NUMBER: 08-084-13

Decklid Opens Unintentionally

2011 - 2013	LD	Charger
2011 - 2013	LX	300

Fig. 1 Passive Entry Switch Button Surface

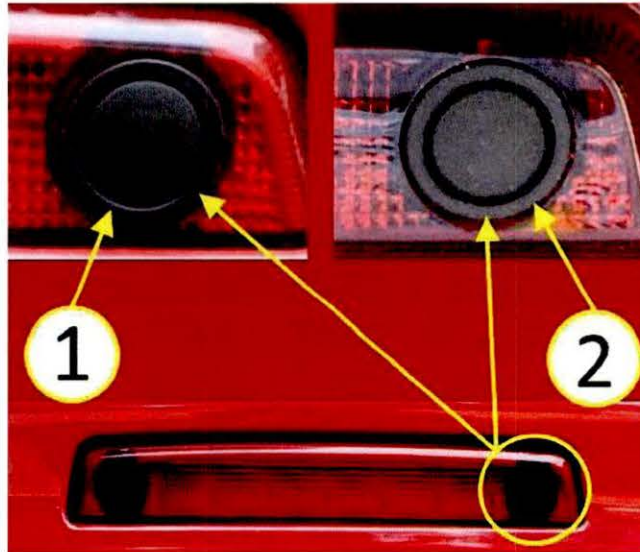
1. Determine if the trunk passive entry switch button surface is plastic (slippery) or rubber (grippy) by rubbing a finger across the switch button surface to detect the surface material. Appearance is very similar and may require careful examination to detect which version of switch is installed (Fig. 1).
 - a. Plastic (1) (Fig. 1) replace the switch, perform the repair procedure.
 - b. Rubber (2) (Fig. 1) no further action is required, return the vehicle to the customer.

Fig. 4 Switch Version

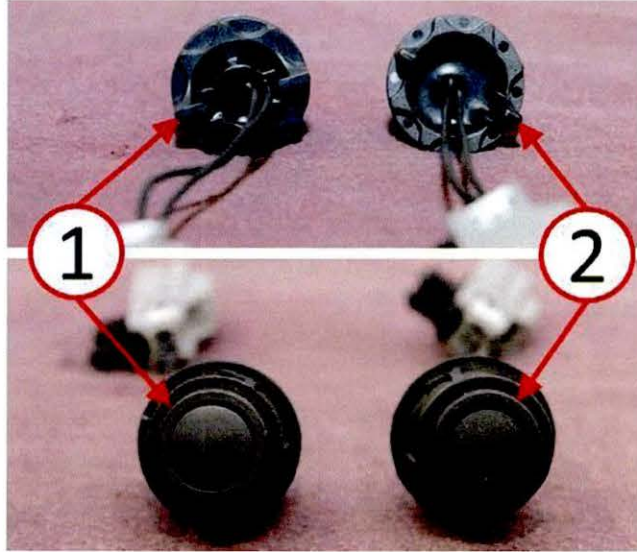
5. Replace previous version plastic button passive entry switch (1) with new version rubber button passive entry switch (2) (Fig. 4).
